REQUEST

Current Zoning: I-2 (CD) (general industrial, conditional)
Proposed Zoning: UR-2(CD), (urban residential, conditional)

SUMMARY OF PETITION

PLANNING STAFF REVIEW

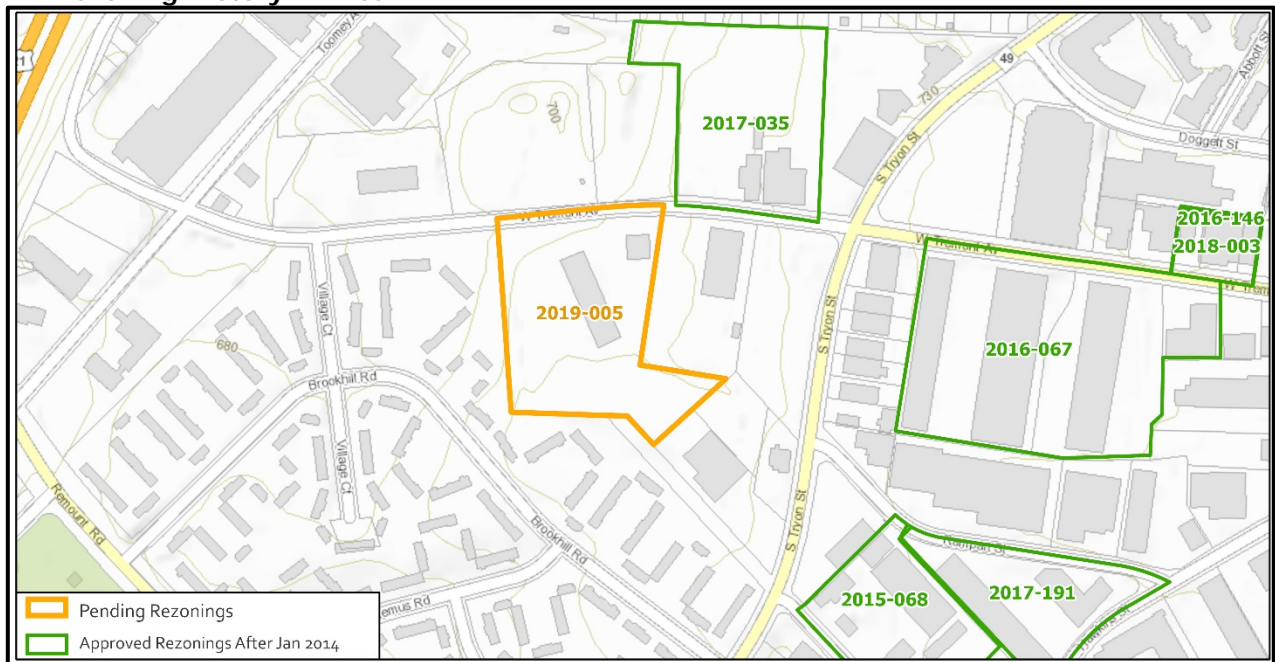
1. Add a note "if on street parking on West Tremont is not provided the site will provide a 21-foot setback from the future back of curb."
2. Label buildings on the schematic plan that will receive the proposed sound mitigation.
3. Modify note in the buffer section that fence can be a maximum of six feet tall.
